**DECLARATION OF BRADLEY J.
HERREMA IN SUPPORT OF
WATERMASTER'S NOTICE OF MOTION
AND MOTION FOR COURT TO
RECEIVE AND FILE THE 2020/2021
ANNUAL REPORT OF THE GROUND-
LEVEL MONITORING COMMITTEE**

Figure 1-1
Historical Land Surface Deformation in Management Zone 1: 1987-1999
 Chino Basin Watermaster
 Ground-Level Monitoring Committee
 2020/21 Annual Report

Figure 3-11

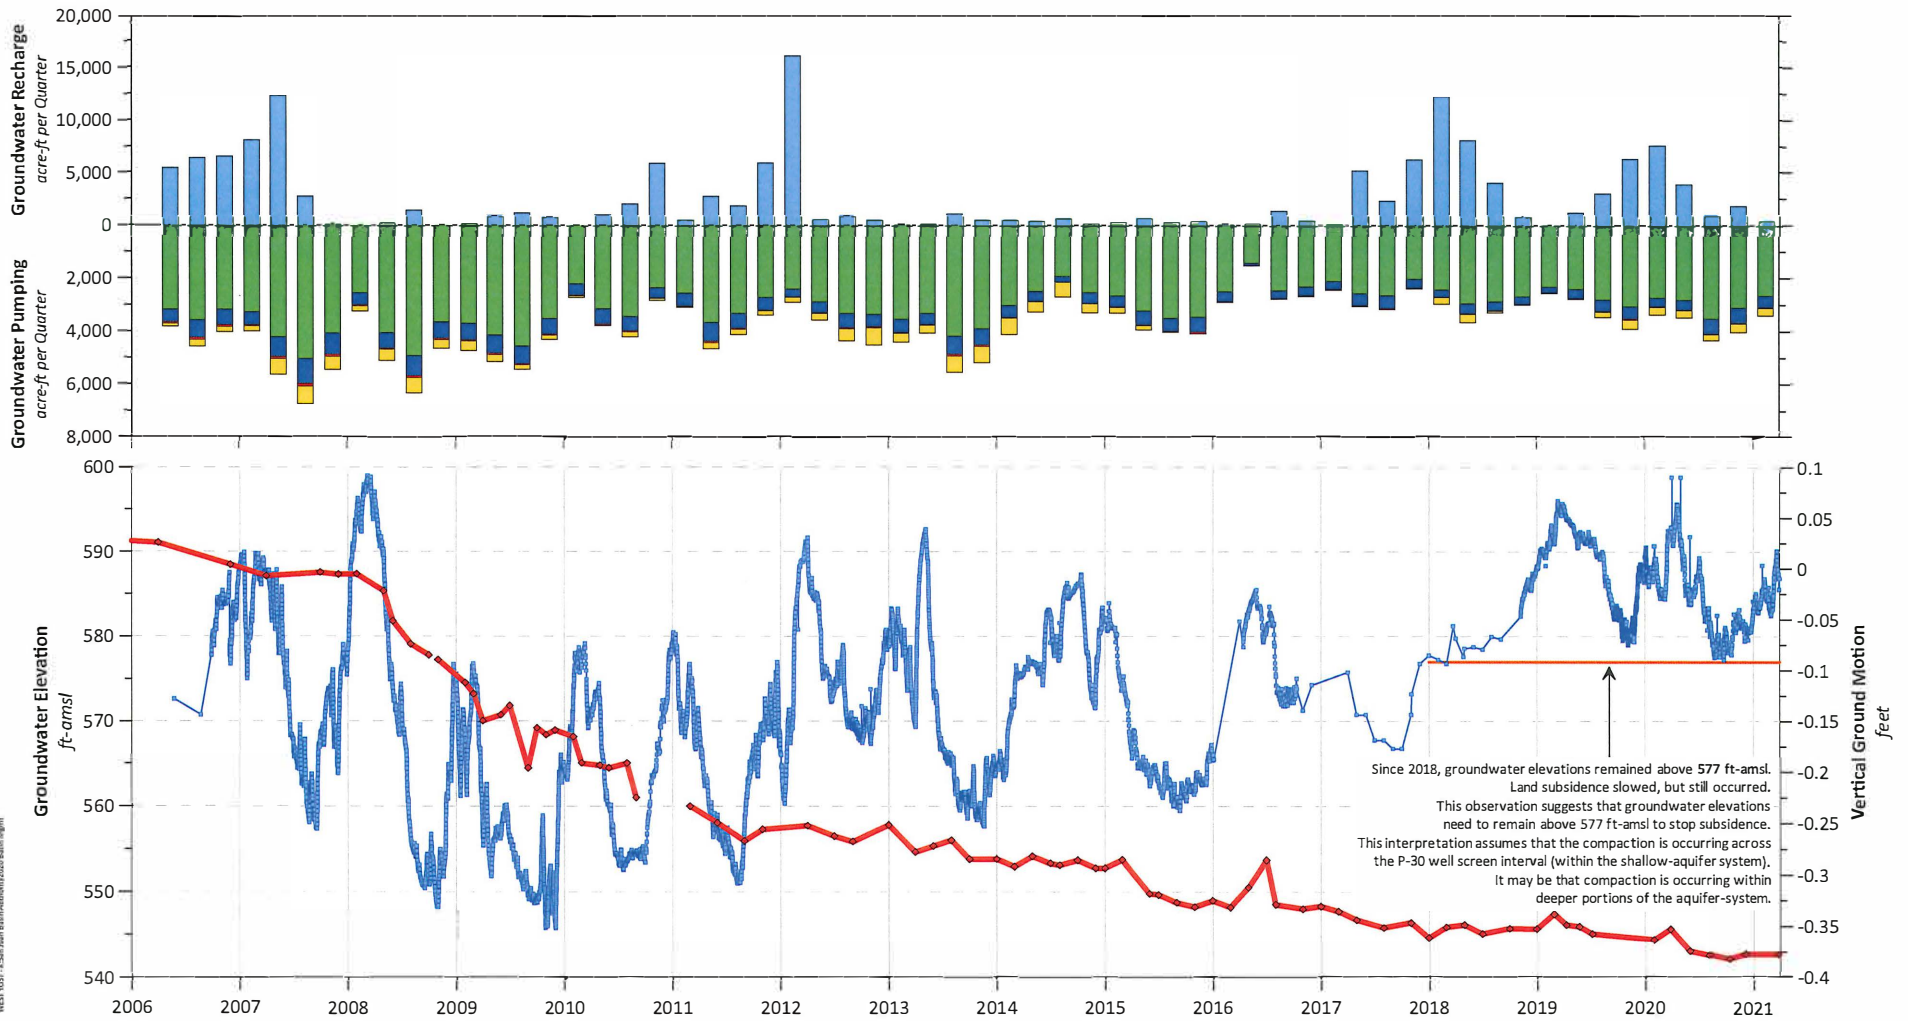
During the September 30, 2021 meeting of the GLMC to discuss the draft 2020/21 Annual Report, Mr. Scott-Coe verbally recommended revisions to Figure 3-11. The recommended revisions included adding clarification to the figure's legend items and adding quarterly recharge from Northwest MZ-1 to the figure.

Figure 3-11 was updated in the final report.

Figure 6-11

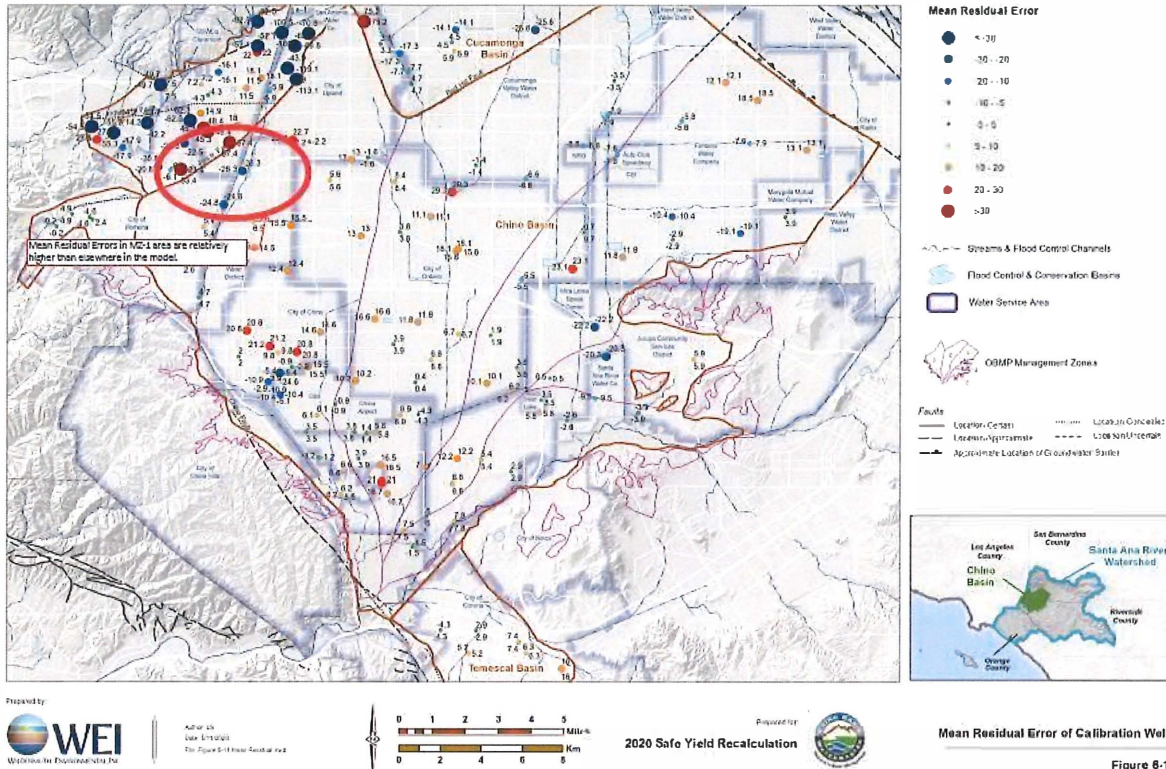
Figure 6-11 “Mean Residual Error of Calibration Wells” from the 2020 Safe Yield Recalculation is reproduced below. The Northwest MZ-1 area shows a high mean residual error relative to other parts of the basin.

The PX facility and the planned extended pumping test will provide layer specific groundwater elevation data. Additional calibration efforts or updates to the conceptual model may be required if predicted water levels in the deep PX completions are not consistent with MODFLOW model predicted water level and model predicted changes in water level.

The TM should provide data on the sensitivity of estimated pre-consolidation stress and other model based subsidence estimates to variation in layer specific model-simulated heads.

Sensitivity analyses for the 1D compaction models should be discussed by the GLMC and added to the scope of work if agreed upon by the GLMC.

Comment 11 – InSAR-Estimated subsidence and Model-Simulated Aquifer System Deformation

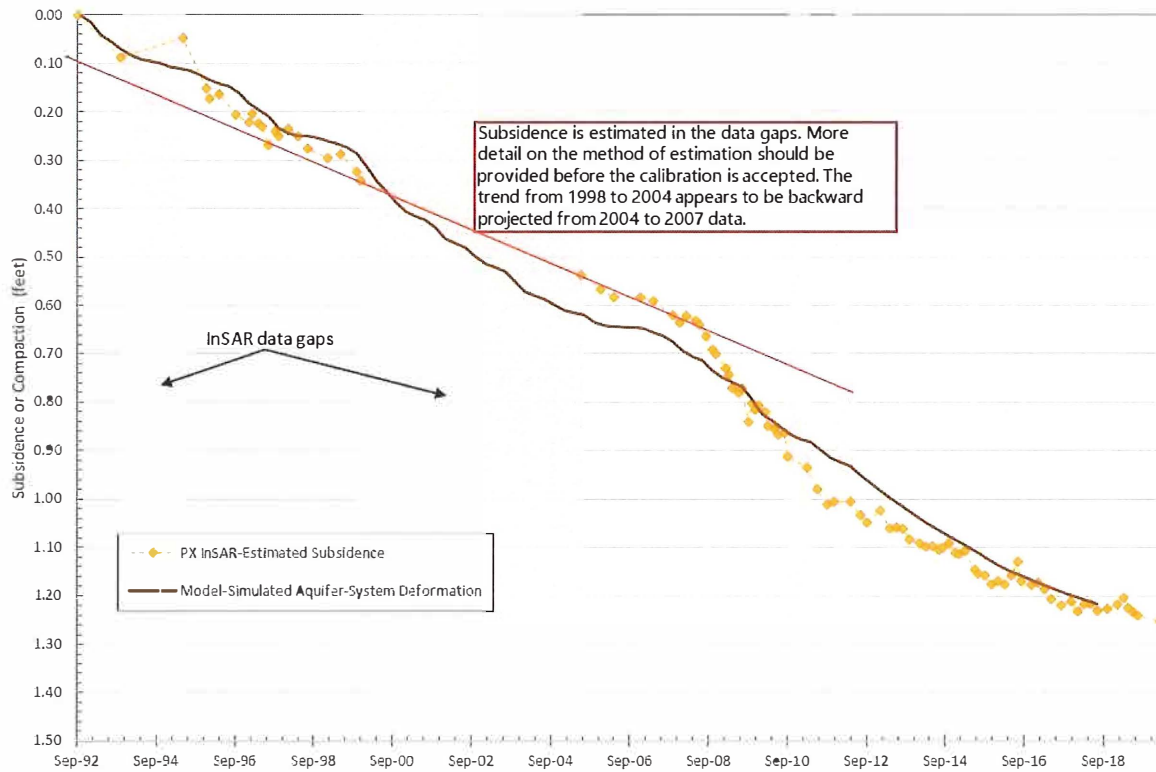
During the March 4 meeting, WY presented InSAR-Estimated subsidence and Model-Simulated Aquifer System Deformation for the PX 1D model. InSAR data gaps were shown, with the InSAR-Estimated Subsidence projected through the data gaps. WY did not provide the method used to estimate subsidence

in the data gap. Additional detail on the method should be provided before the calibration is accepted. The prediction trend appears to be backward projected from September 2004 to late 2007 levels.
